Great Yarmouth Third River Crossing Order 202[*]

Document NCC/GY3RC/EX/064: Response to Written Submissions made by the Environment Agency at Deadline 5

Author: Norfolk County Council

Date: 11 February 2020

Row 13: 2D domain is too small as it impacts tidal inundation from the north and the south (i.e. blue arrows in below image), especially at higher tidal events

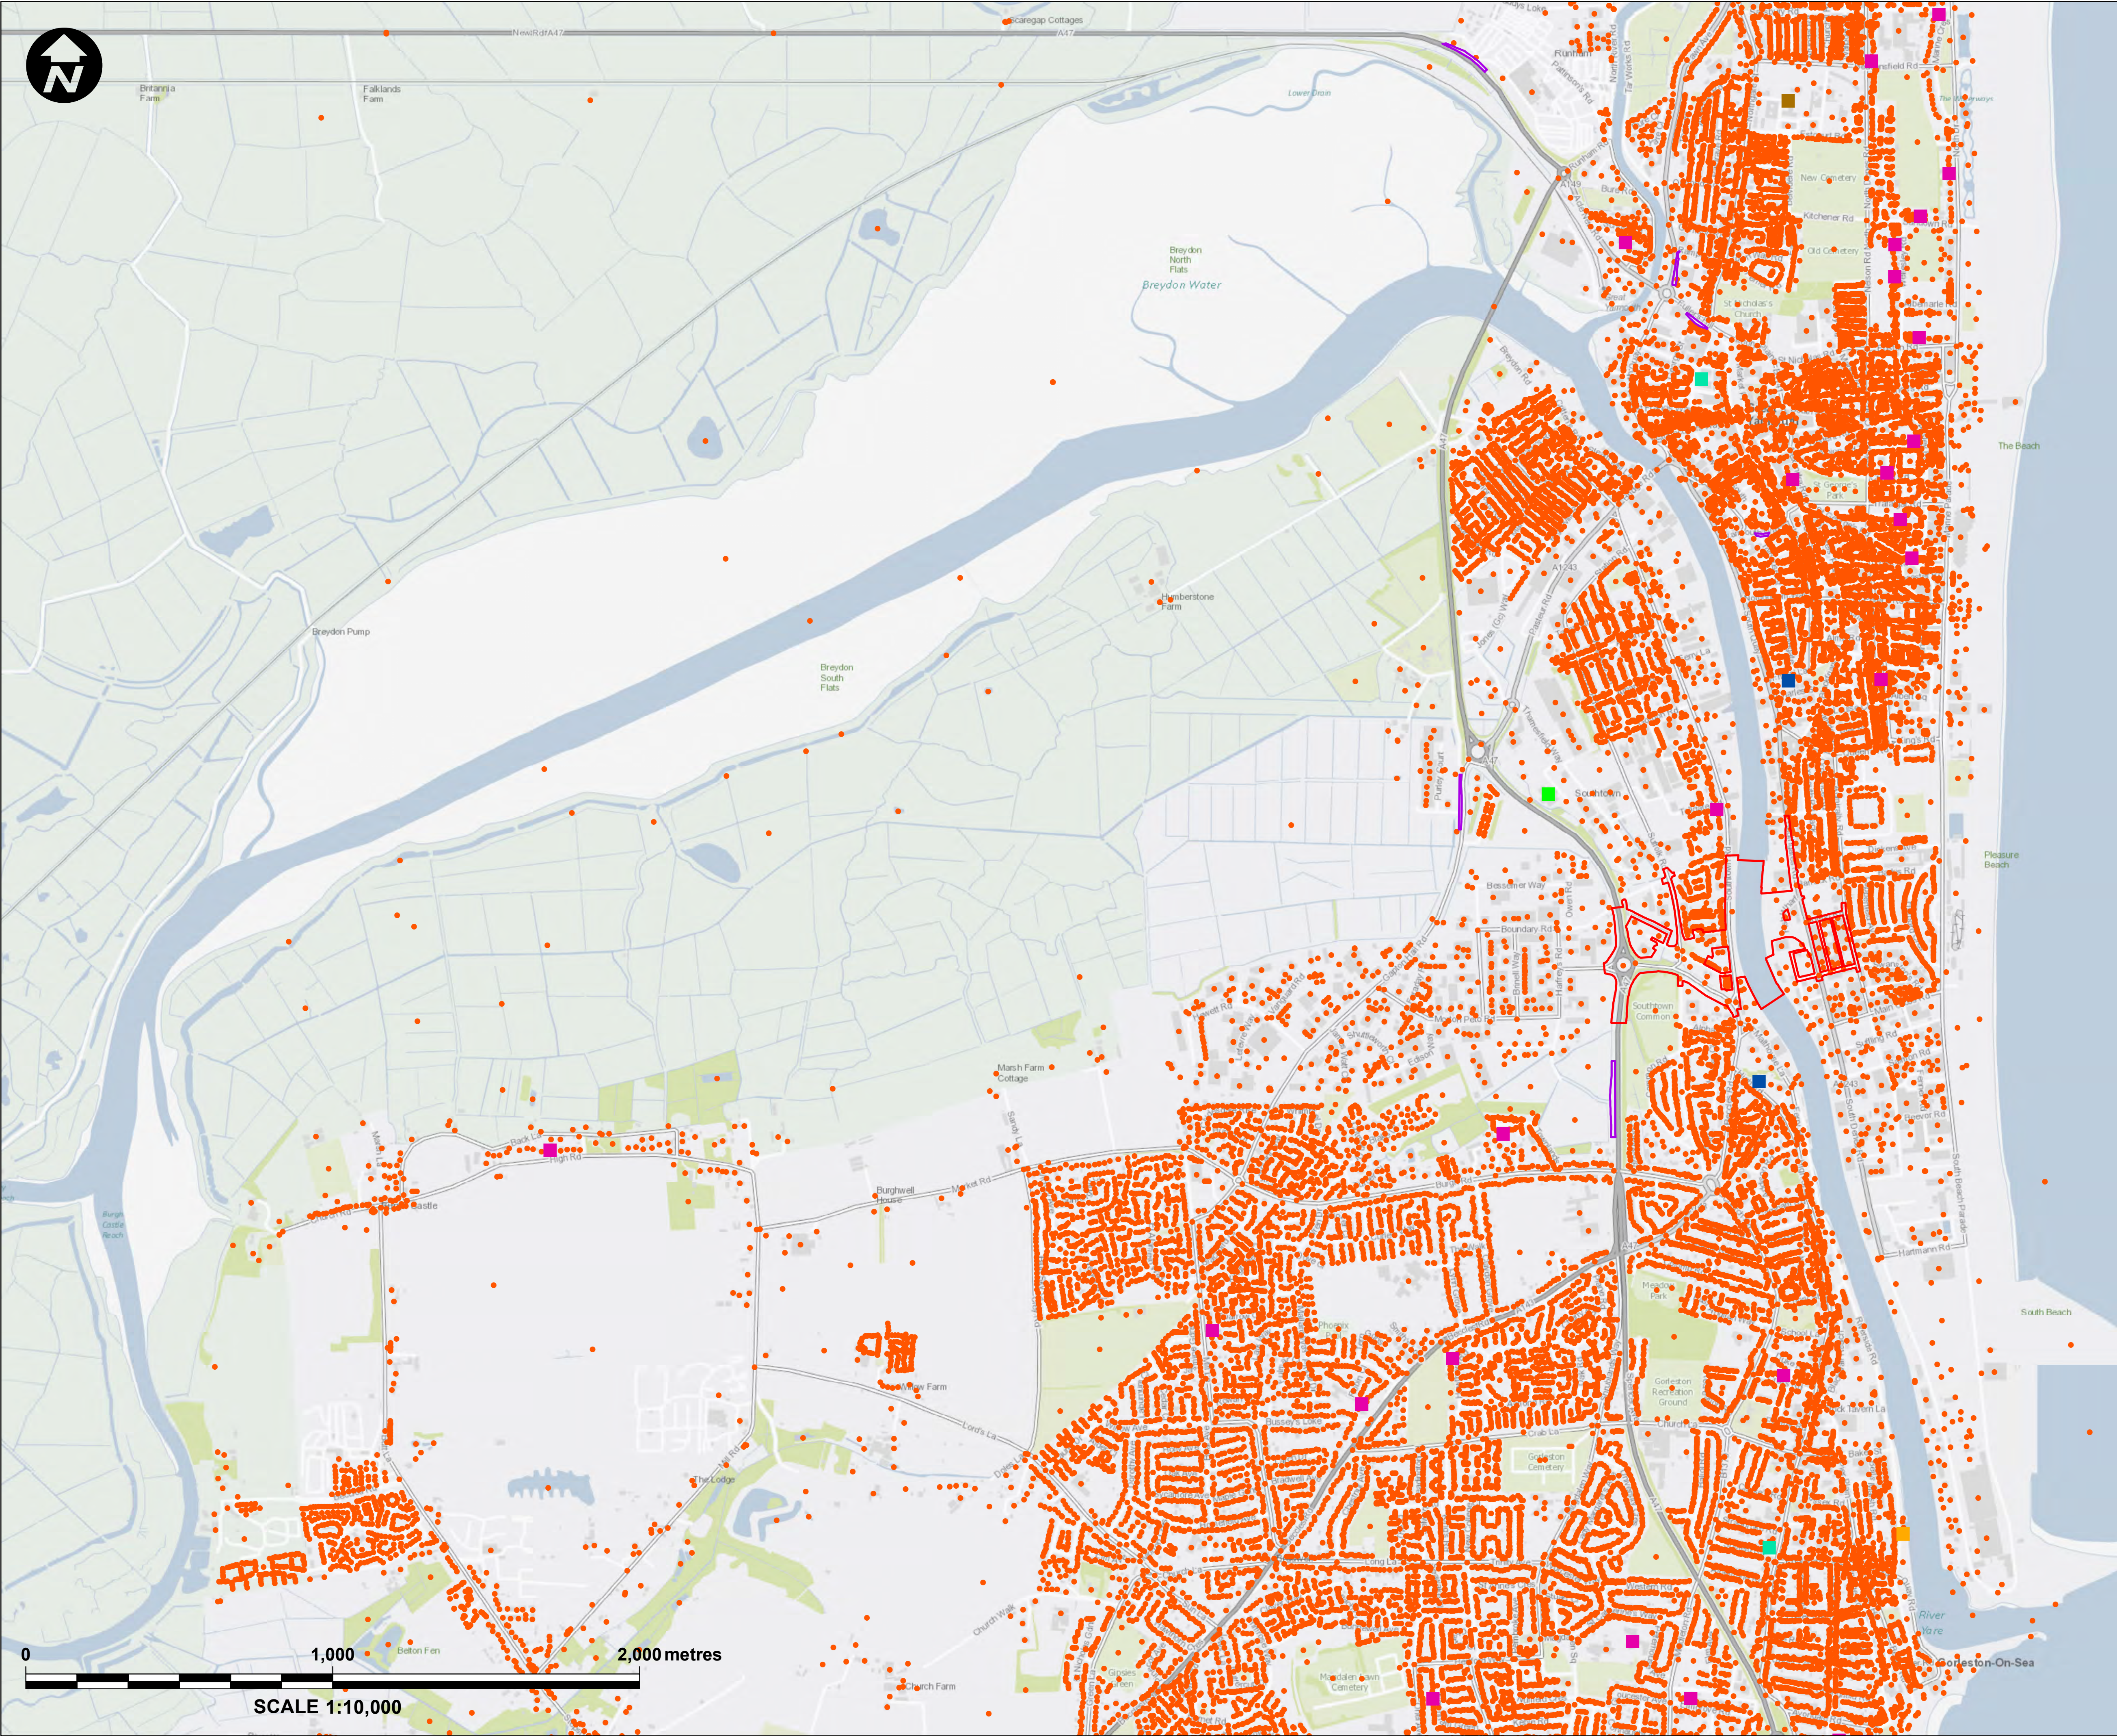
"Make the 2D domain larger. As a guide, the smallest 2D domain should be roughly the same size as Halcrow 2011, particularly on the sea facing side. If expanding the model domain, make sure any additional structures (e.g. bridges, culverts, subways etc) are included in new domain."

In November, the Environment Agency noted that the model had been re-run for all scenarios with the revised domain. However, results were only supplied for the T200 event for the modified baseline and that the modified scheme model the T1000 results are not complete. They requested full results along with versions of *tables 9 and 10 from the report*, so that an up to date comparison can be made (the tables are included in Chapter 6 of the Flood Risk Assessment (Document Reference 6.2, Planning Inspectorate Reference APP-135) and numbered Table 6.9 and 6.10).

This was submitted by the Applicant, as part of the further sensitivity modelling on the 21st and 22nd of October for the T200 event for the extended baseline.

As requested the Applicant has now undertaken all runs and these accompany this memorandum.

FIGURE 12B.1
FLOOD RISK RECEPTORS IDENTIFIED
WITHIN ASSESSMENT STUDY AREA
(REGULATION 5(2)(e))

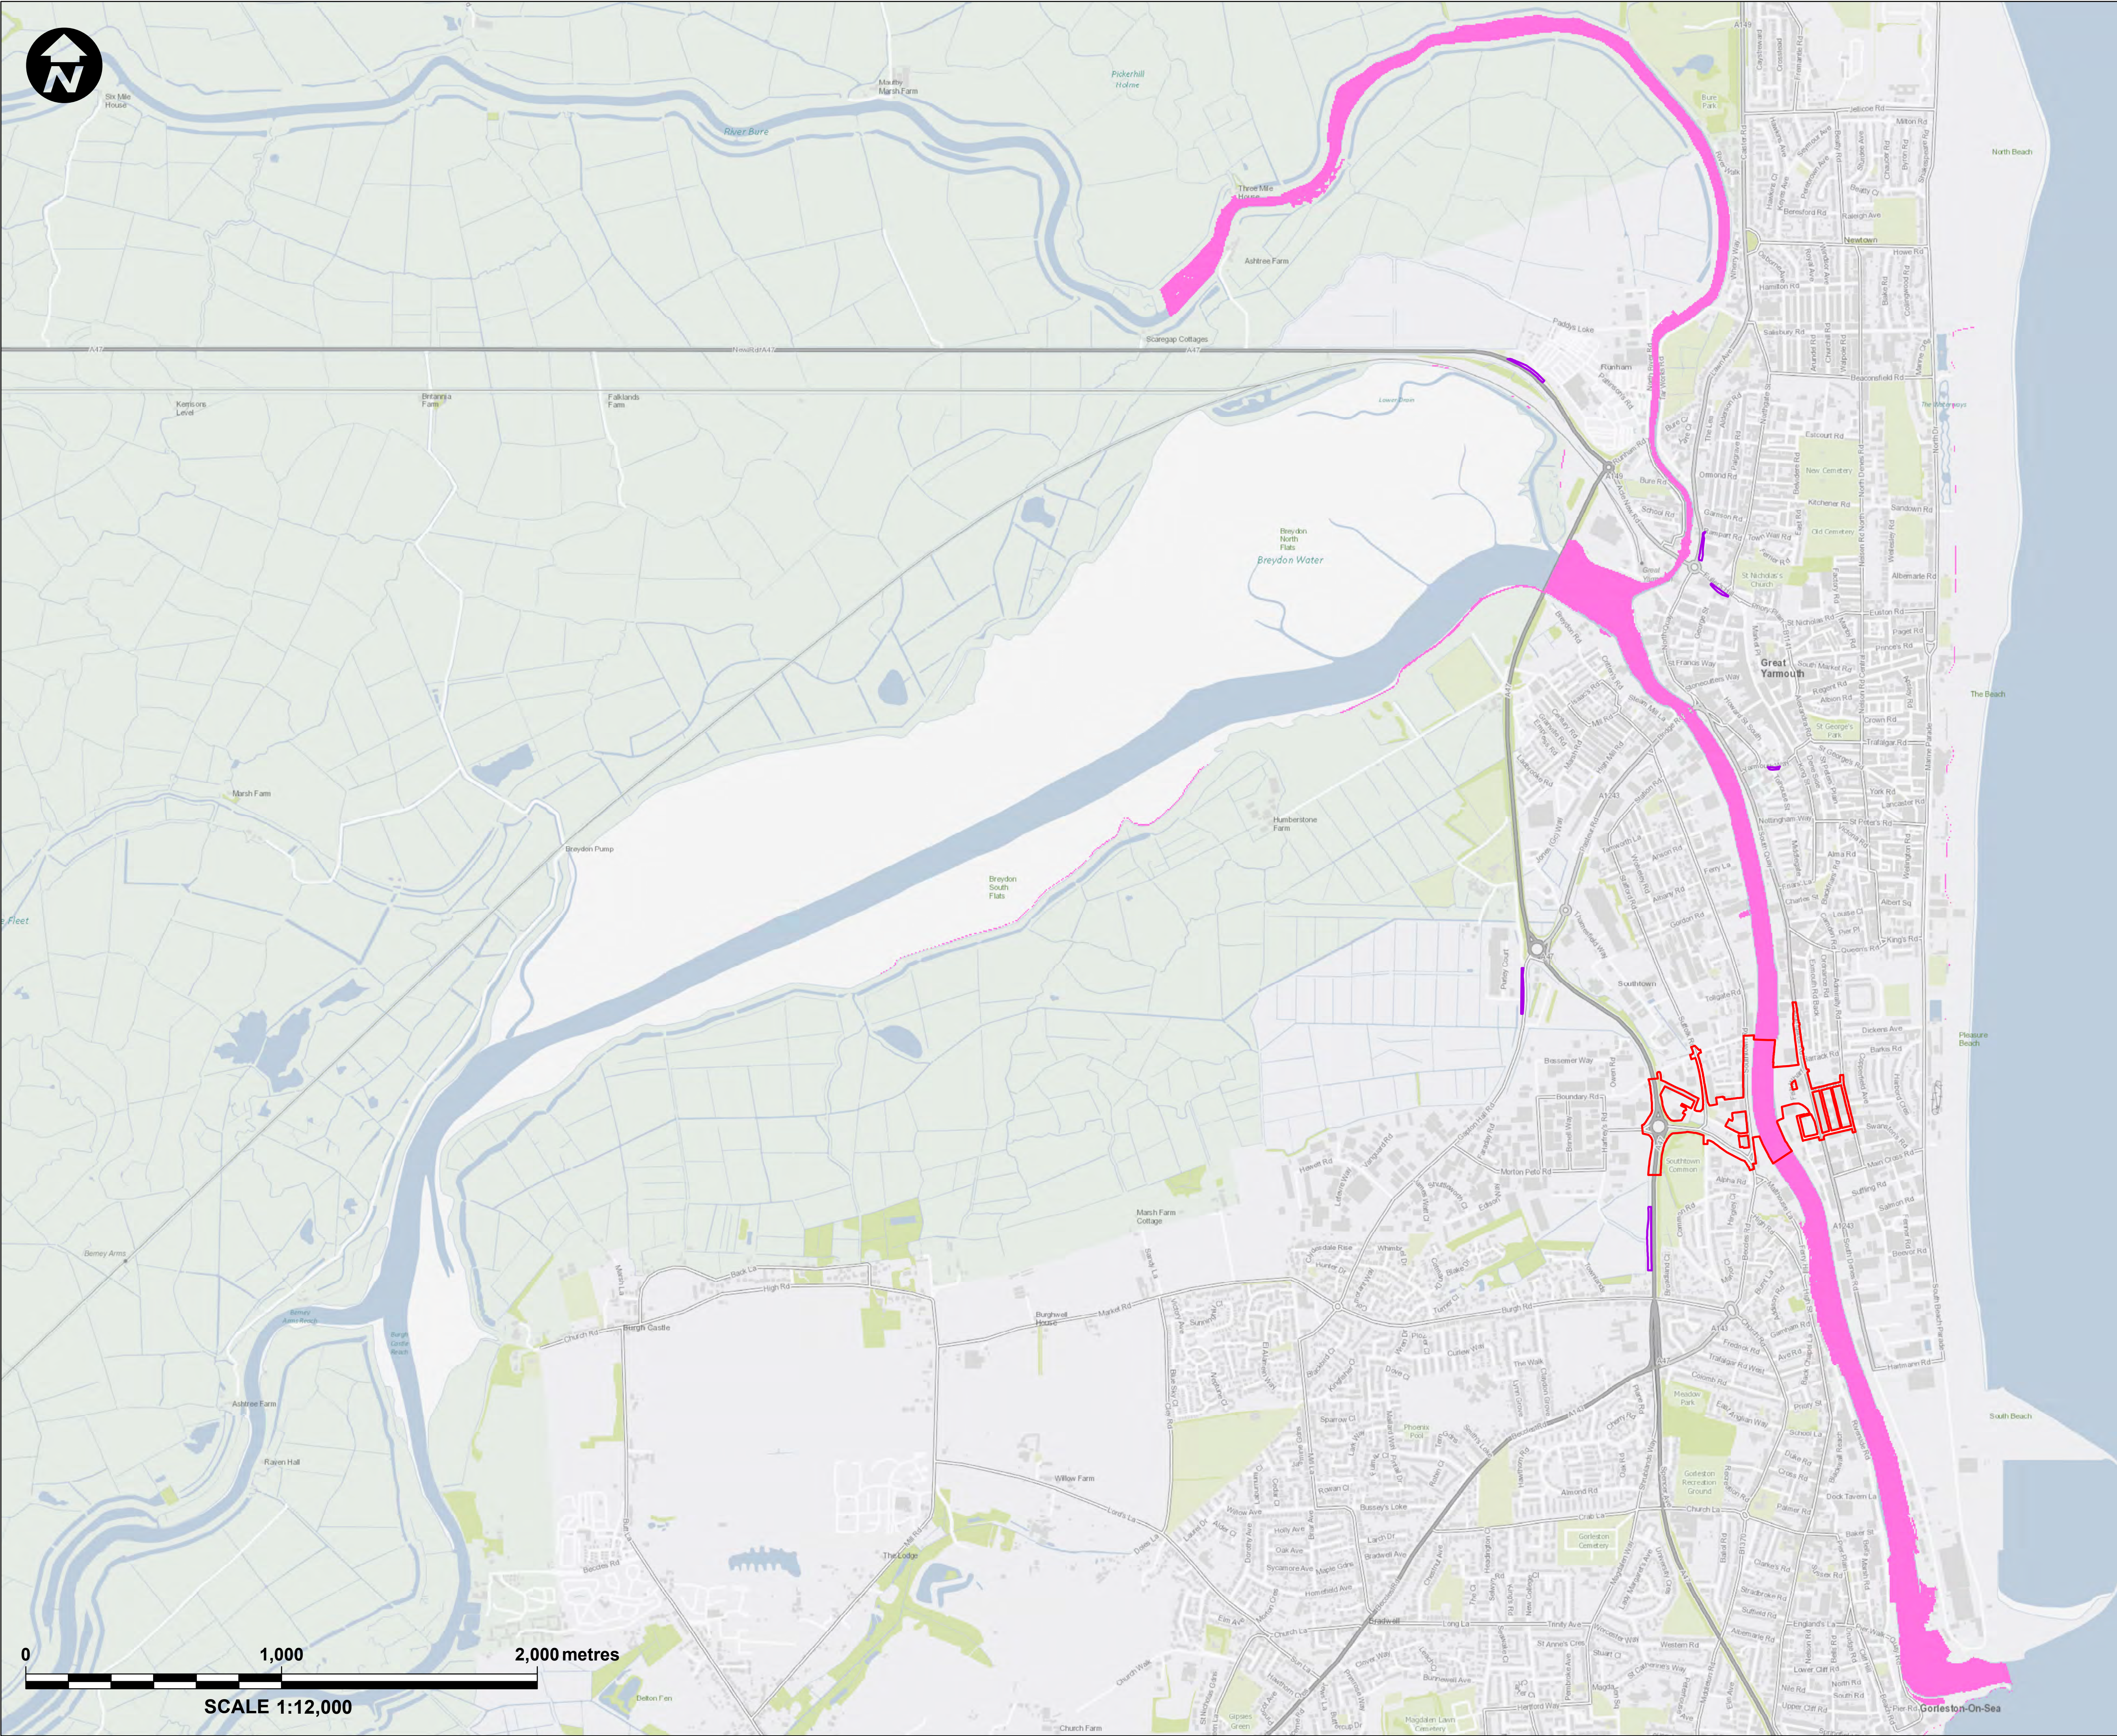
- 2.1.16** Figure 12B.1 of the Appendix shows the flood risk receptors identified within the assessment study area. We have concerns that this figure appears to be missing a substantial amount of receptors that are relevant to the site. It is likely that a significant number of these missing receptors are dwelling properties. This issue was raised with the Applicant in April 2019. If this figure is showing the receptors that have been used in the FRA, then the Applicant will at least need to account for why significant numbers of receptors in areas close to the scheme are not accounted for and it may be necessary to re-assess those receptors.

- 2.1.19** The Applicant acknowledges the erratum in Figure 12B.1 in that it does not contain all receptors as noted by the Environment Agency. The Applicant can

confirm that all receptors contained in the OS Address Base Data were included in the modelling which underpins the FRA (Document Reference 6.2, Planning Inspectorate Reference APP-135).

- 2.1.20 A corrected version of Figure 12B.1 without the erratum is included as Appendix B to this Written Submission.
